Title of Change:	FUSB251UCX New Carrier Tape Design Qualification
Effective date:	24 Oct 2022
Contact information:	Contact your local onsemi Sales Office or Michelle.Lyn.Alaba@onsemi.com
Type of notification:	This Product Bulletin is for notification purposes only. onsemi will proceed with implementation of this change upon publication of this Product Bulletin.
Change Category:	Assembly Change
Change Sub-Category(s):	Material Change

PCN#: PB24809X
Issue Date: Aug 09, 2022

Qualification of New Carrier Tape Design for FUSB251UCX WLSCP Device

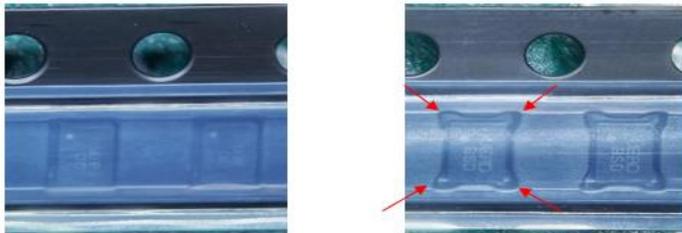
New carrier tape design with Corner relief for FUSB251UCX WLCSP Device with changes comparison as below:

FROM: No Corner Relief

TO: With Corner Relief

Carrier Tape	Details	Chipping All Side Inspection	Remarks	Result
New Carrier Tape with Corner Relief	Reel Form; 1 meter	0/100	No chipping anomaly found	Passed
	Reel Form; 1.5 meter	0/100	No chipping anomaly found	Passed
	Reel Form; 2 meters	0/100	No chipping anomaly found	Passed
	Intermediate Box; 1 meter	0/100	No chipping anomaly found	Passed
	Intermediate Box; 1.5 meter	0/100	No chipping anomaly found	Passed
	Intermediate Box; 2 meters	0/100	No chipping anomaly found	Passed
	Shipping Box; 1 meter	0/100	No chipping anomaly found	Passed
	Shipping Box; 1.5 meter	0/100	No chipping anomaly found	Passed
Shipping Box; 2 meters	0/100	No chipping anomaly found	Passed
